# Product Change Notification

Product Group: SFERNICE / Sept 30<sup>th</sup> 2019 / PCN-SF-237-2019 Rev 0

## SFERNICE WIREWOUND RESISTORS New Enamel Qualification

## Enamelled coating examples

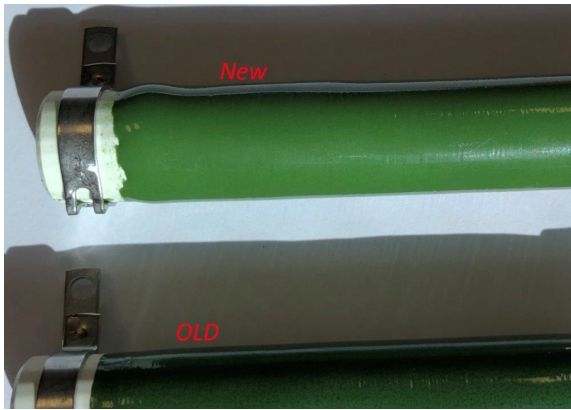
New Enamel is ROHS compliant but will be fully Lead Free while current Enamel is ROHS compliant using exemption 7(c) I. Color remains the same see pictures in page 2.
